Serial No.: 09/764,649
Amendment Dated: December 23, 2003
Reply to Office Action of June 26, 2003

R E M A R K S

FIG. 5

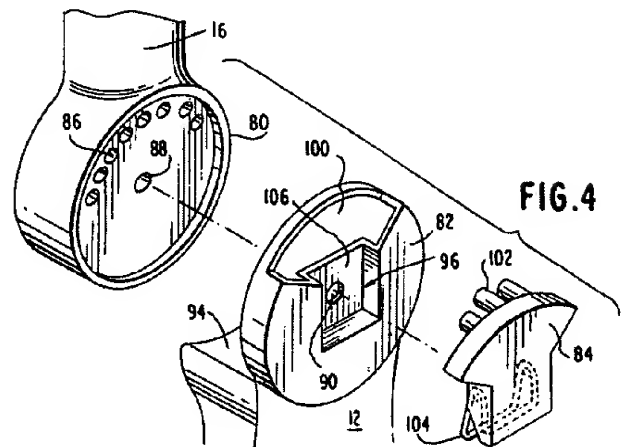
The comparable fastening technology taught by Ampian is depicted in Figure 5 and consists of a pivot pin 92:

Although Ampian then notes, "any conventional manner of pivotally connecting the lock receiving member 80 to the lock supporting member would suffice," Ampian specifically provides additional structure to support the pivot

pin (92) connection between the coupling member 16 and the handle 12:

An arcuate bearing surface 94 is provided on the lock supporting member 82 to assist in supporting the lock receiving member 80, as illustrated in FIG. 4. (Col. 4, line 68 - Col. 5, line 3).

The narrow slot formed between the arcuate bearing surface 94 and the matching circular outer surface of the coupling member invites rotational immobility

caused by dripped, then dried paint or cleaning solutions.

The arcuate bearing surface of Ampian is unneeded and unwanted where Applicant provides a connector bolt that is fixedly attached to the angular locking plate.
